NOTICE OF APPROVAL

Planning Case #: Design Review 22258

Project Description: Plantings, irrigation, and low-level landscape lighting at 5th Avenue 2 NW of San Carlos in the Service-Commercial (SC) District as depicted in the plans prepared by RANA Landscape Architecture, stamped approved on September 1, 2022 and on file at the Community Planning & Building Department, unless modified by the conditions of approval. This approval also authorizes a slightly revised trellis design (previously approved under DR 22-170) three trellis-mounted heaters.

PROJECT TITLE
CHEZ NOIR
5TH AVENUE
CARMEL, CALIFORNIA

Metal Fence Elevation
scale 1" = 1' - 0"

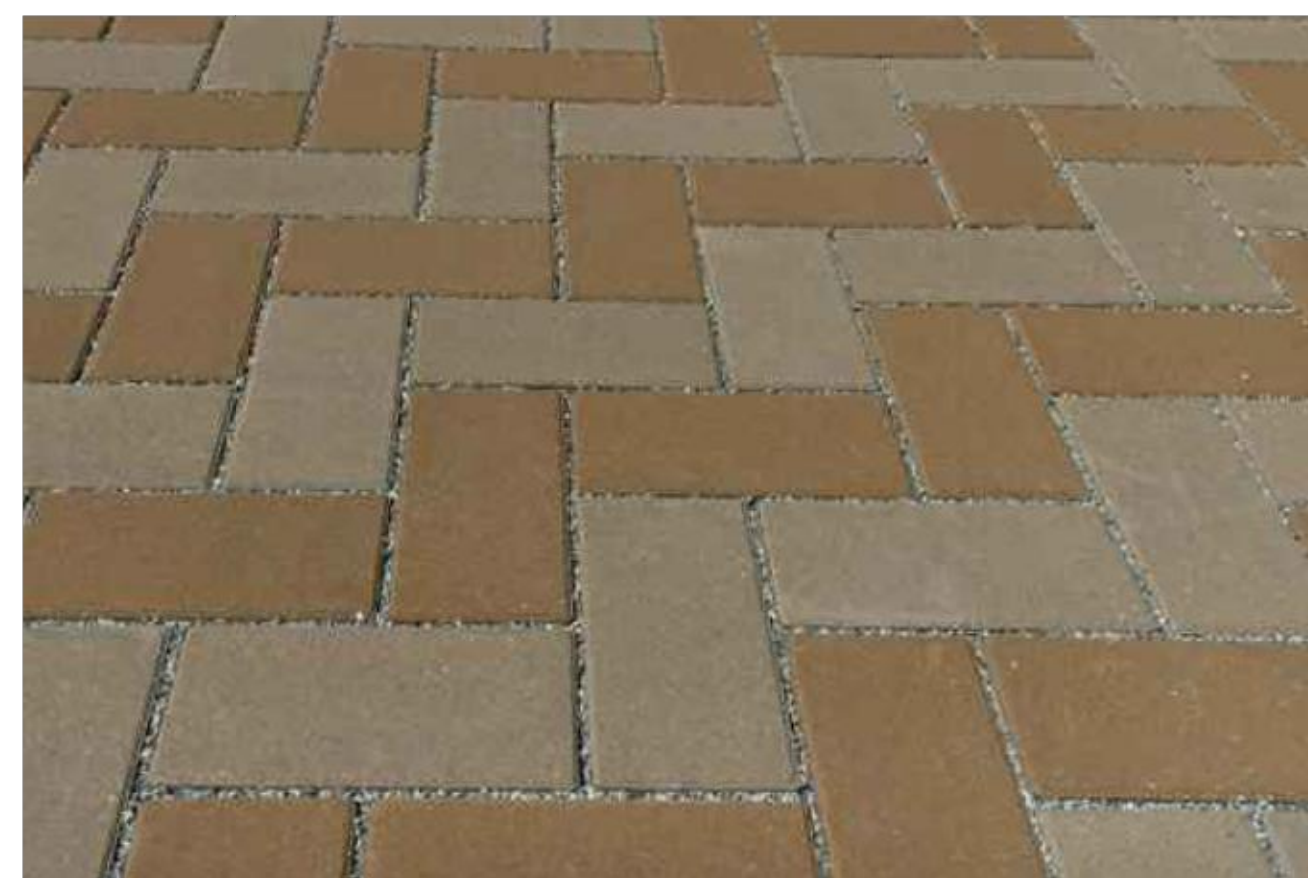
Special Conditions	
11.	<p>Fence. Prior to the issuance of a building permit the applicant shall revise the drawings to reflect a wood fence along the west property line, consistent with Design Review approval DR 19-227 (Great Valley Holdings, LLC) and building permit BP 20-251, rather than a metal fence as proposed.</p>	✓

PROPERTY LINE TRELLIS

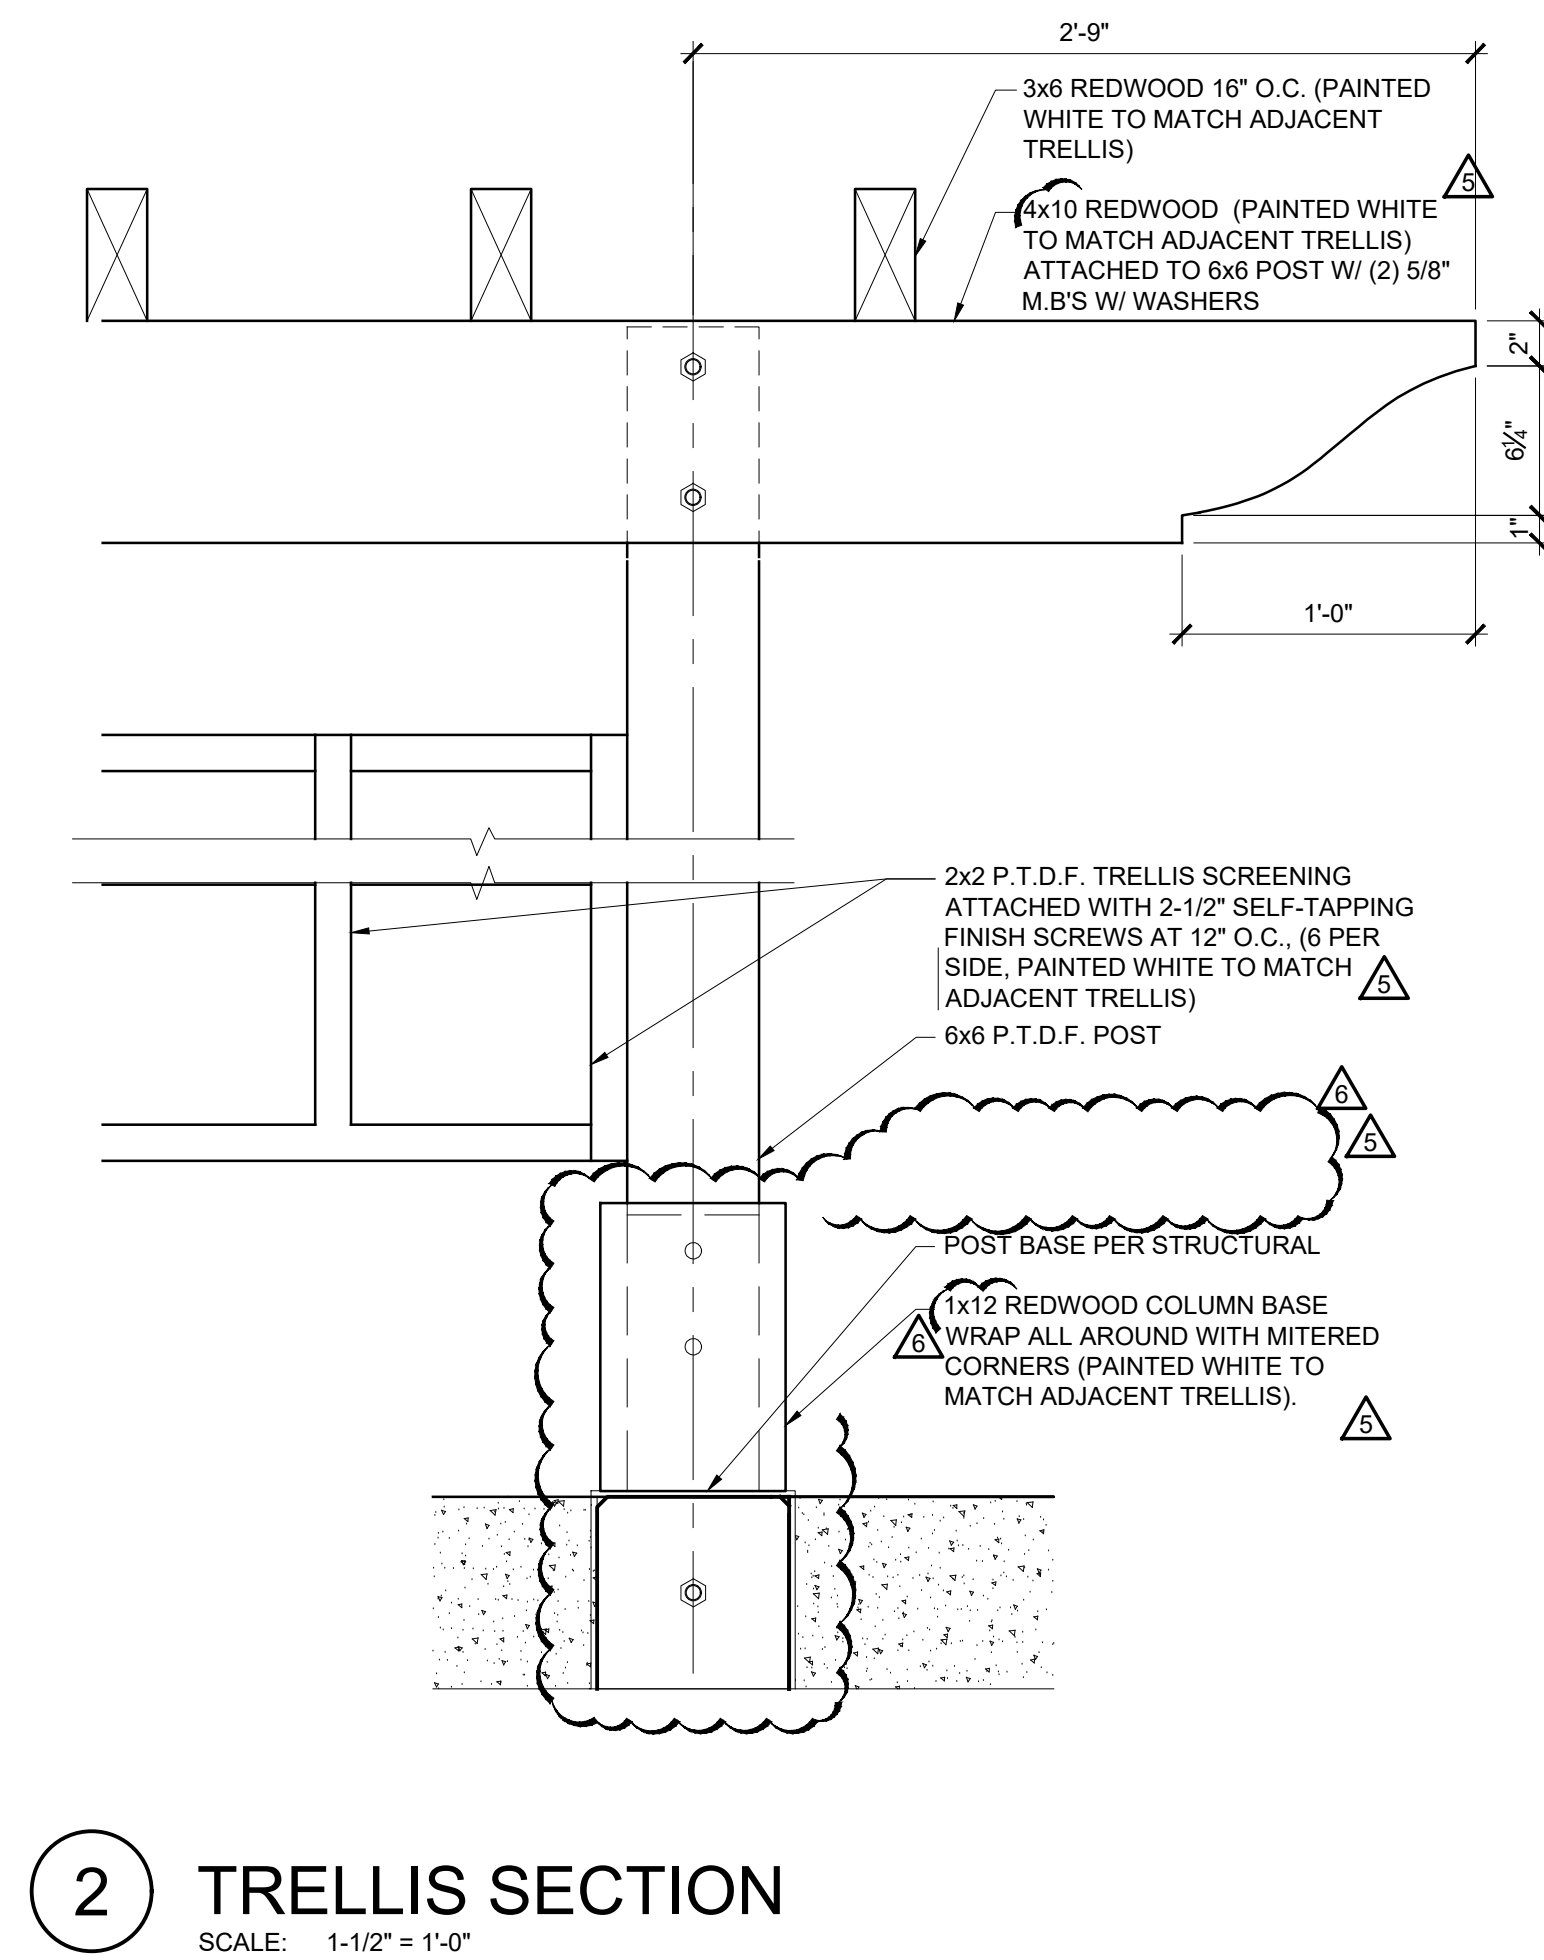
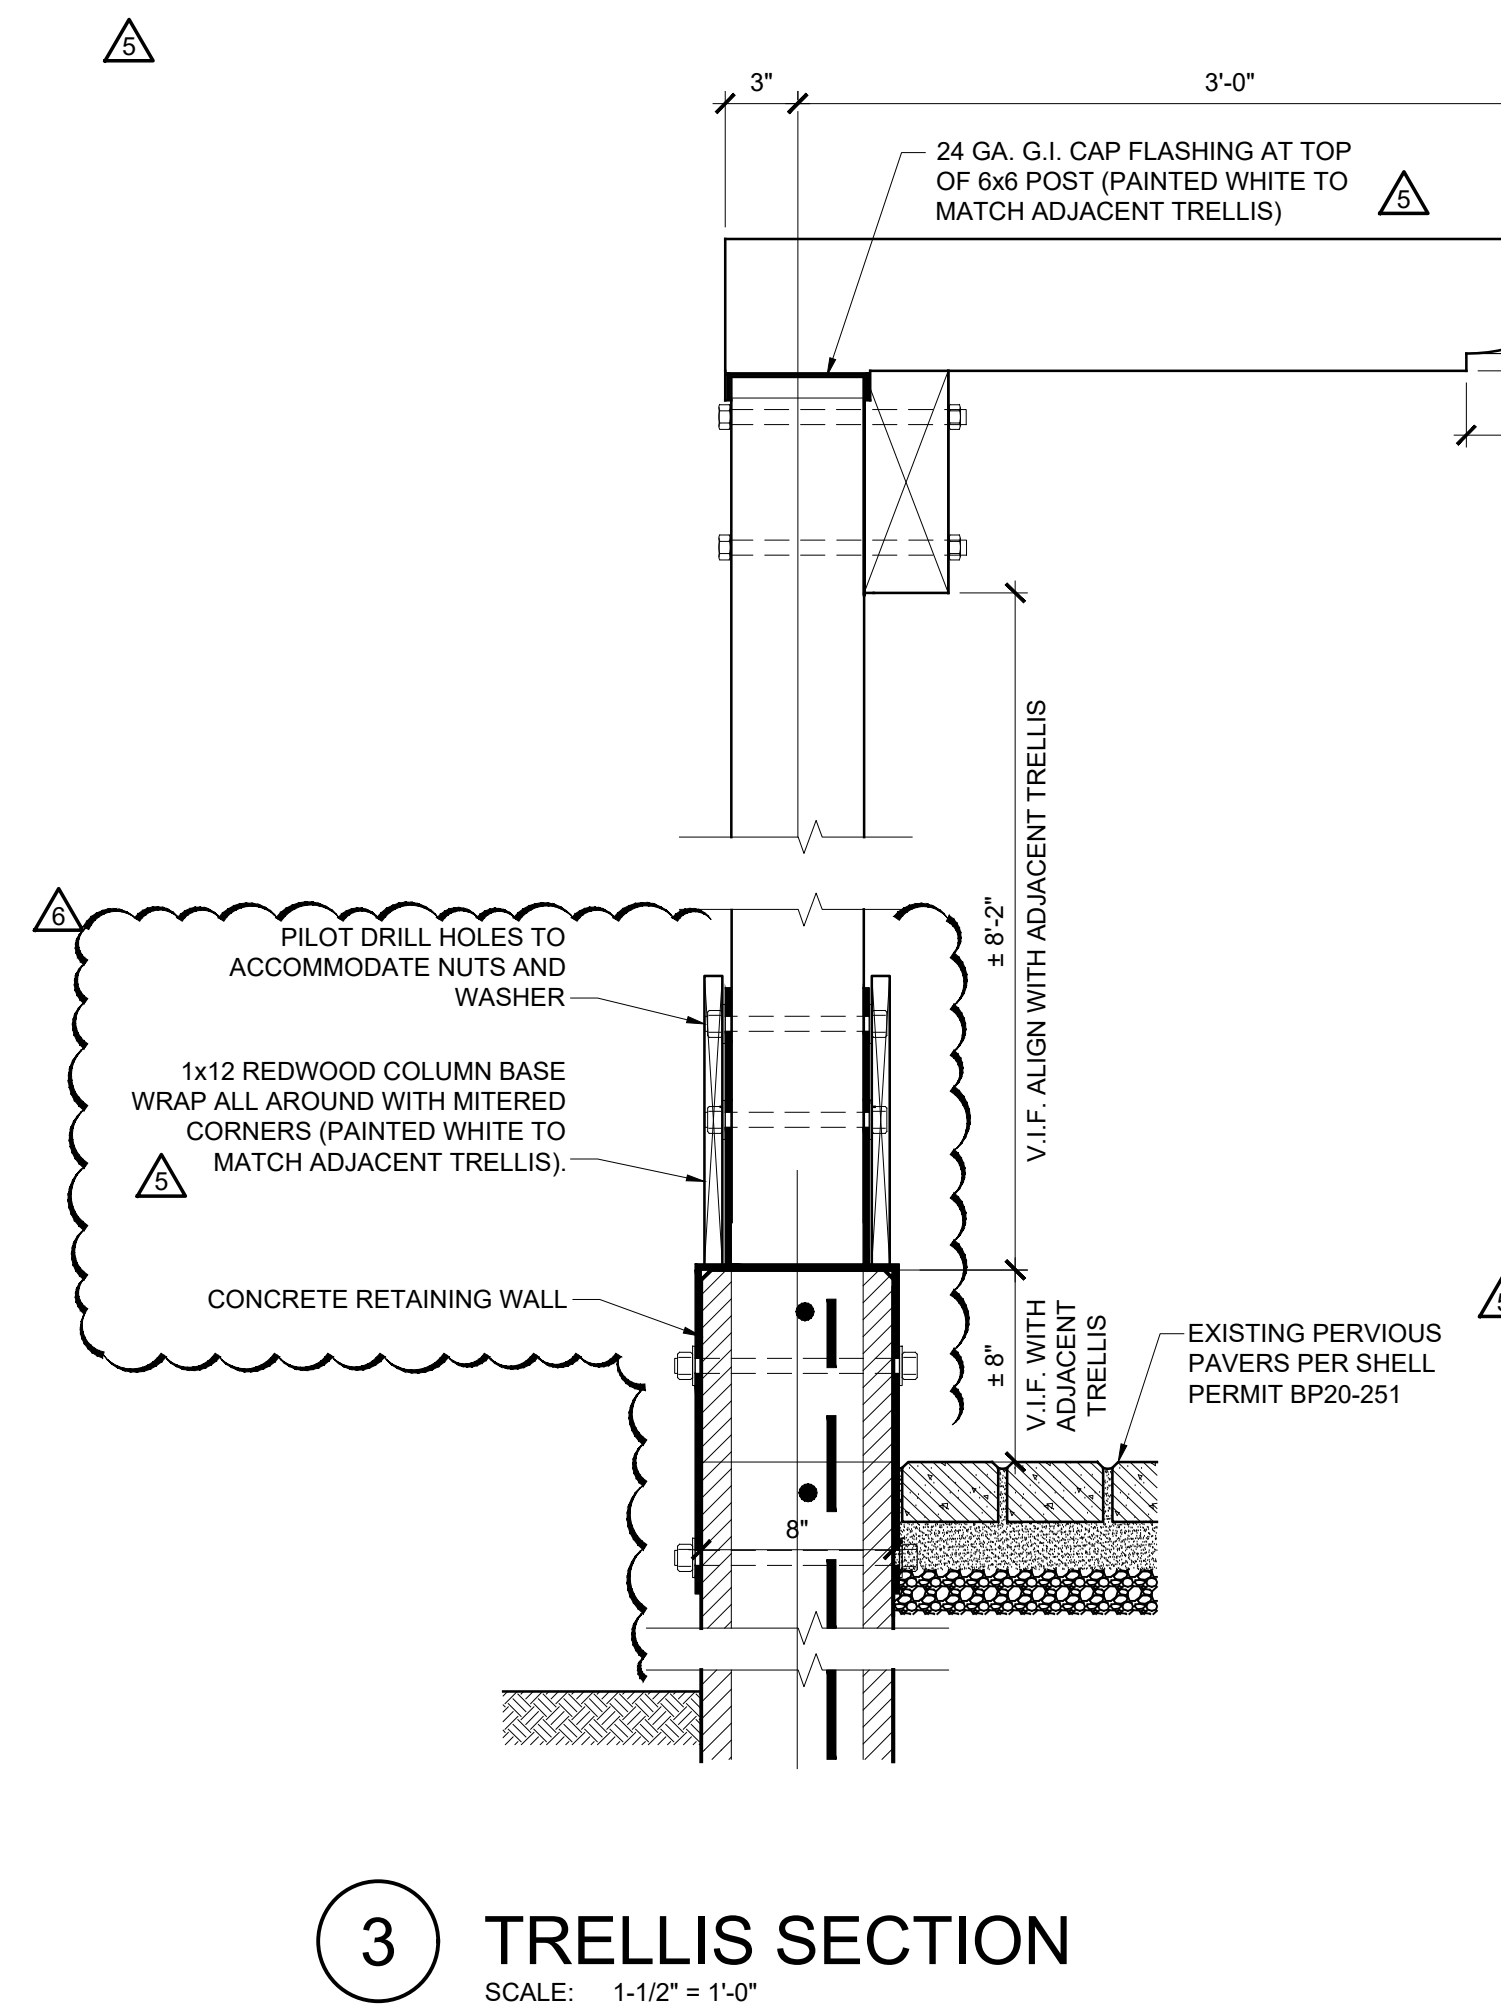
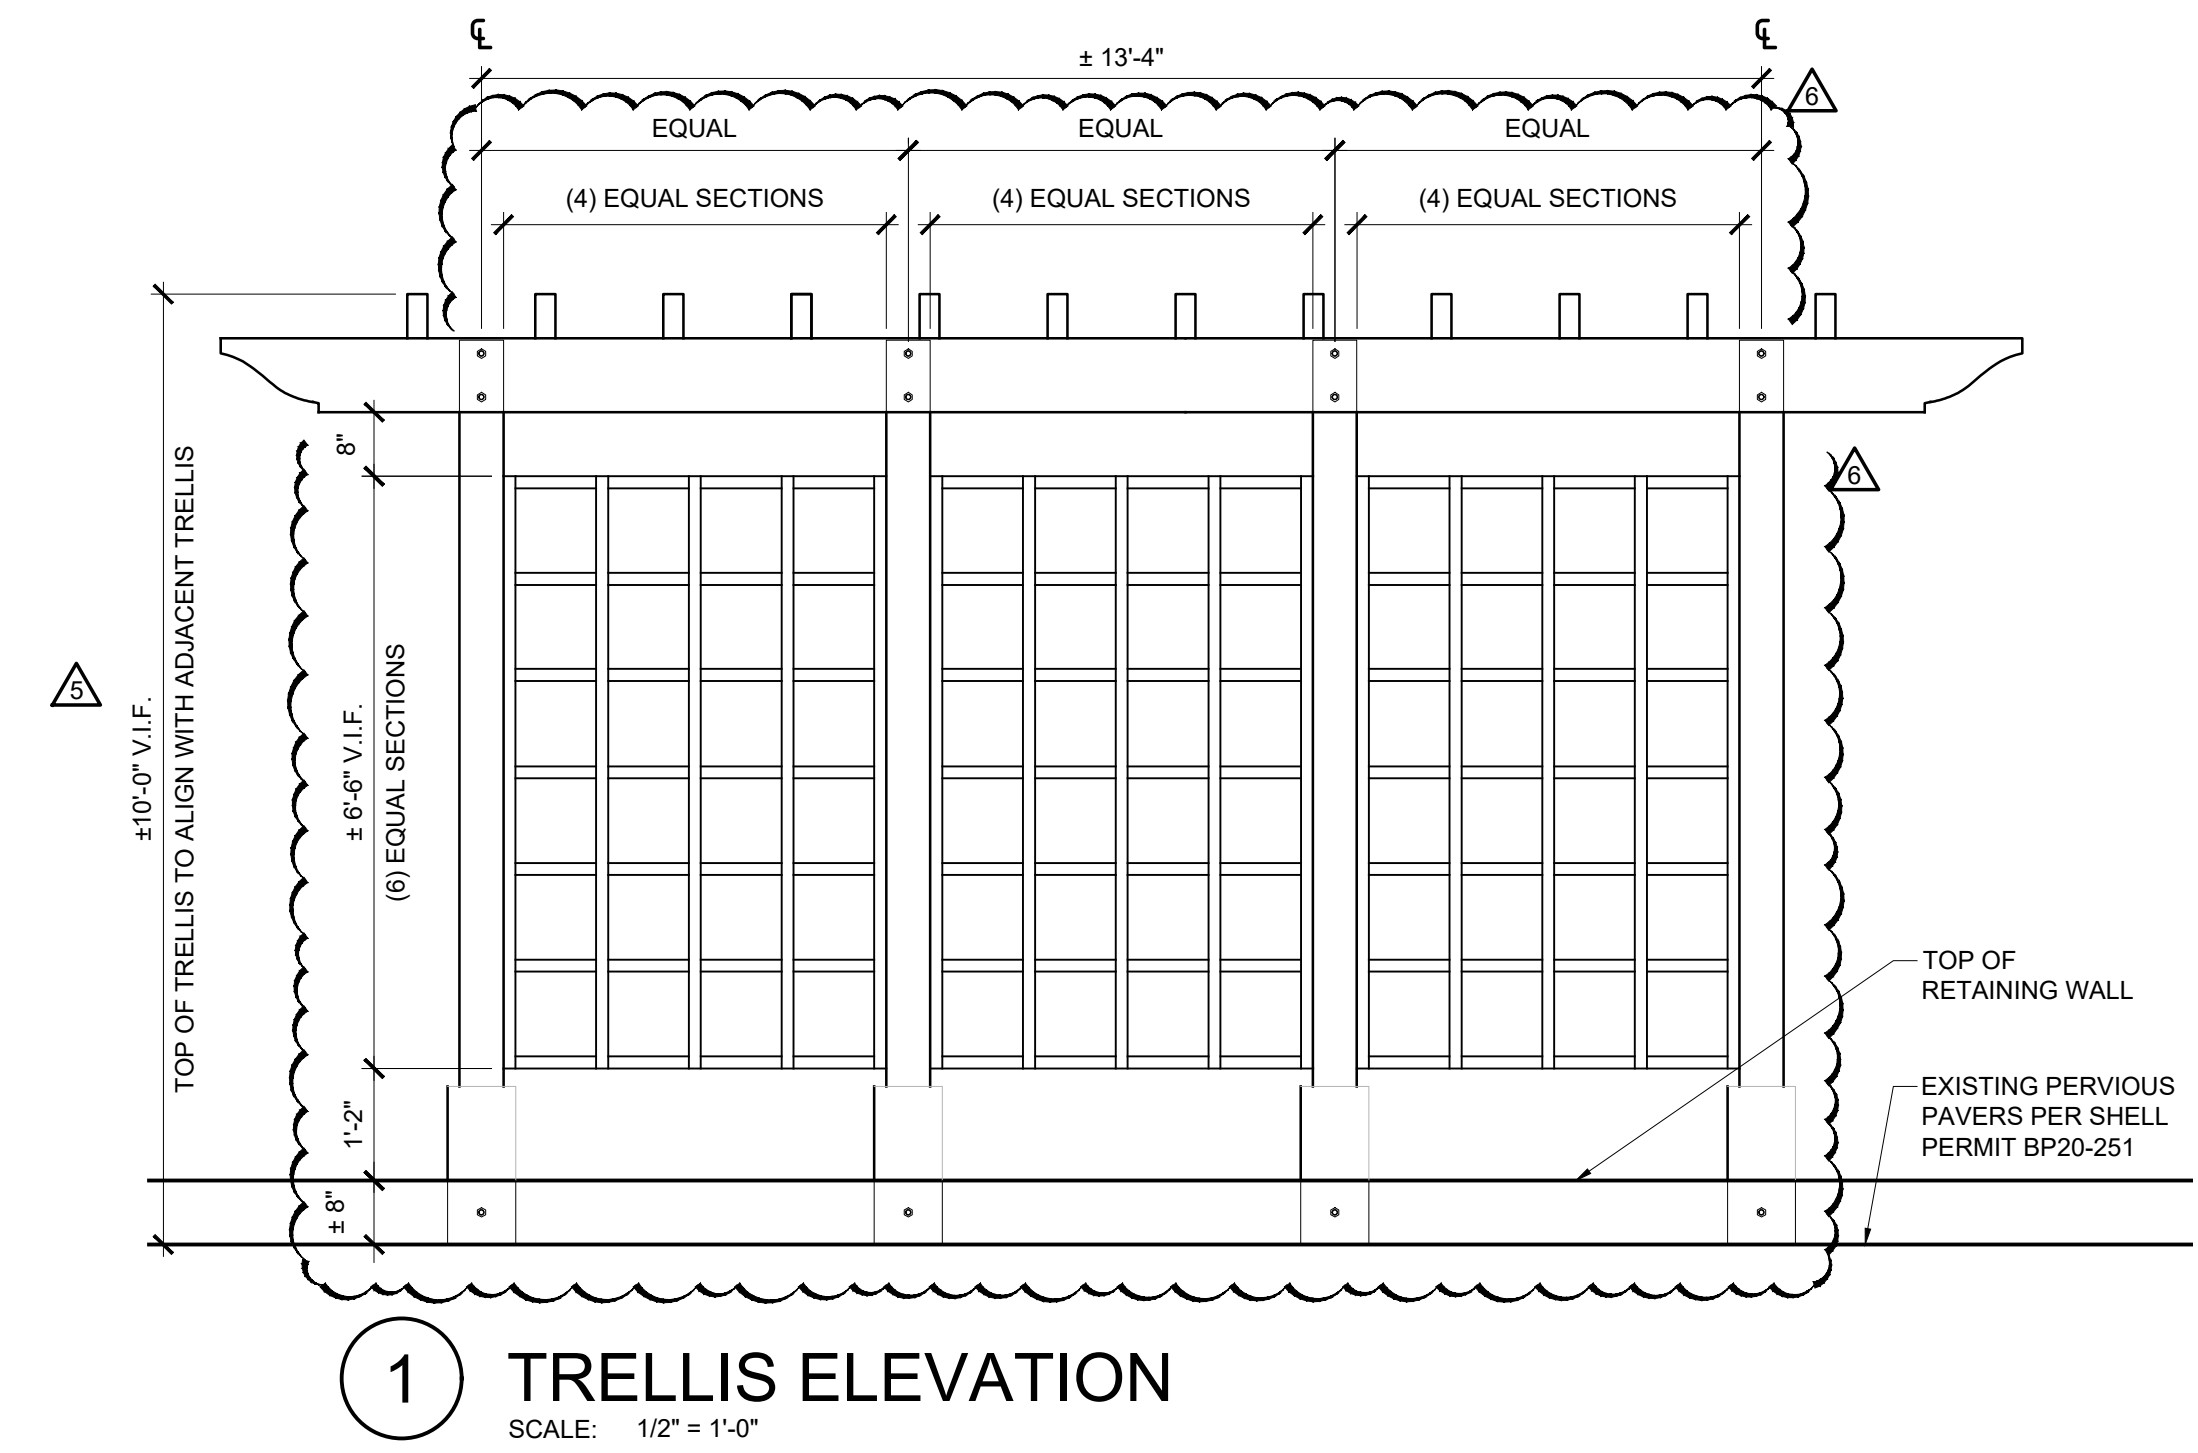
12.	<p>Heaters. Prior to the issuance of a building permit, the applicant shall submit a dimensioned elevation detail depicting the heater installation on the trellis. The mounted heaters shall be shielded from view from the public right-of-way OR shall be designed to be architecturally compatible with the village character and adjacent building, per CMC 17.14.220.D.</p>	✓

13.	<p>Lighting. This approval does not authorize the installation of lighting on or attached to the trellis.</p>	✓
14.	<p>Tree. Prior to final inspection, the applicant shall select and install one of the following trees for the tree well in the public right-of-way: catalpa; cultivated aesculus (not californica); linden; hackberry; zelkova; dogwood; pistache; cork oak; elm; honeylocust; coffee tree- male; or ginkgo- male.</p>	✓
